SERVICE BULLETIN

M-1006

1991 ALTERNATOR ROTOR AND COMPENSATING SPROCKET SPACING

Alternator Rotor and Compensating Sprocket Assembly

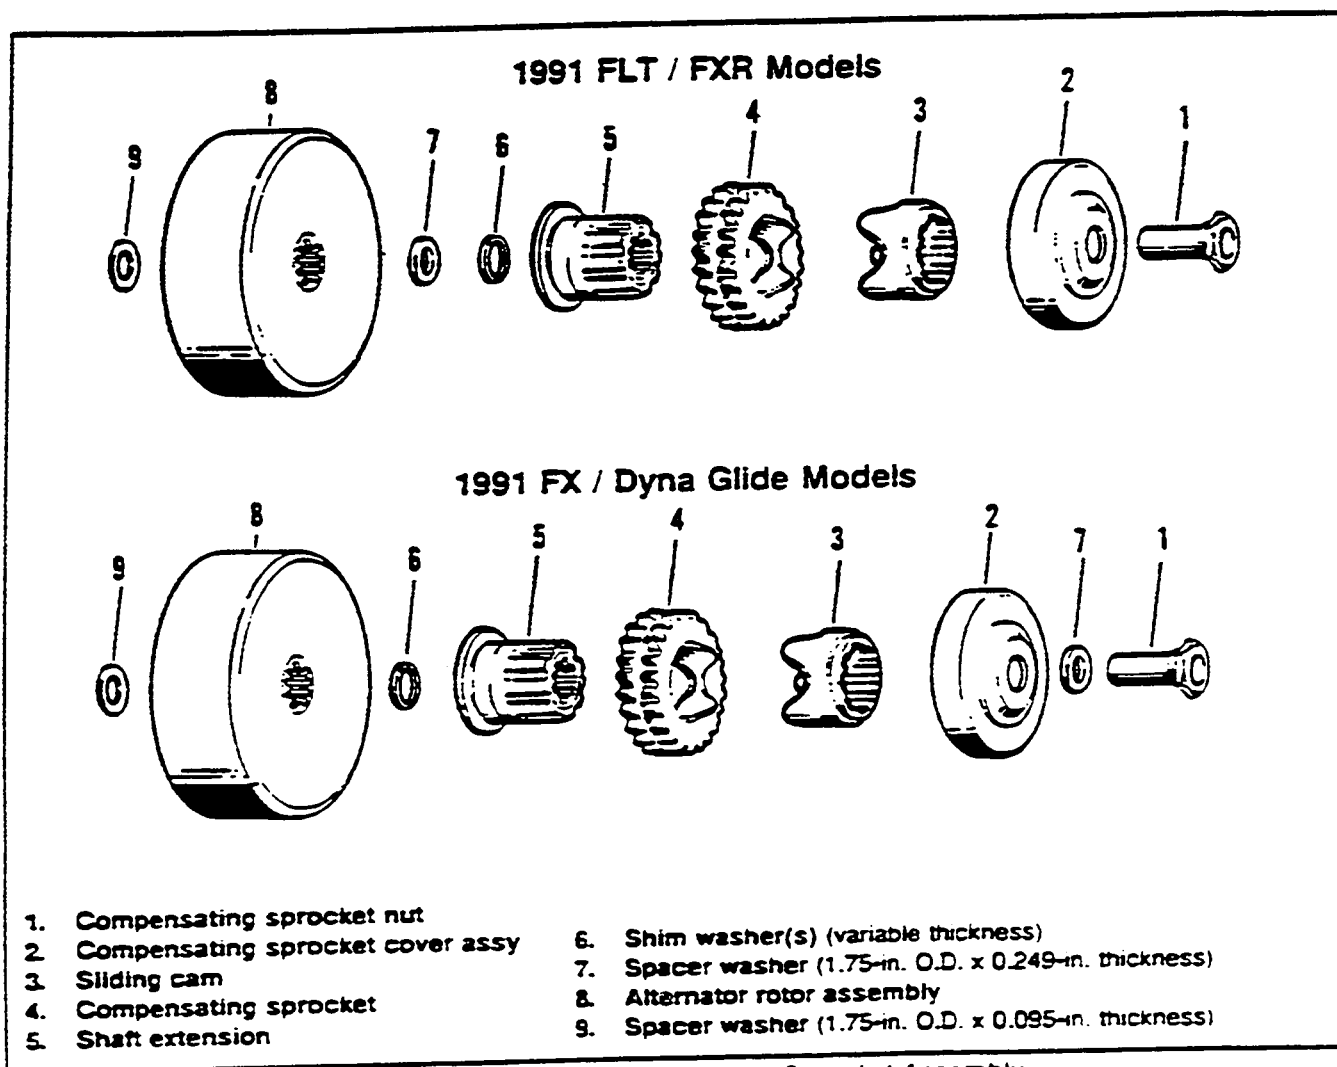
All Big Twin models have a 1.75-in. O.D. x 0.095-in. thick spacer washer (9) immediately inboard of the alternator rotor assembly (8) on the sprocket shaft.

On 1991 FLT / FXR models, a 1.75-in. O.D. x 0.249-in. thick spacer washer (7) is positioned immediately outboard of the rotor, followed by a variable thickness shim washer(s) (6), and then the shaft extension (5).

On 1991 FX / Dyna Glide models, the variable thickness shim washer(s) (6) is positioned between the rotor and the shaft extension (5); the 1.75-in. O.D. x 0.249-in. thick spacer washer (7) is positioned between the compensating sprocket cover assembly (2) and the compensating sprocket nut (1).
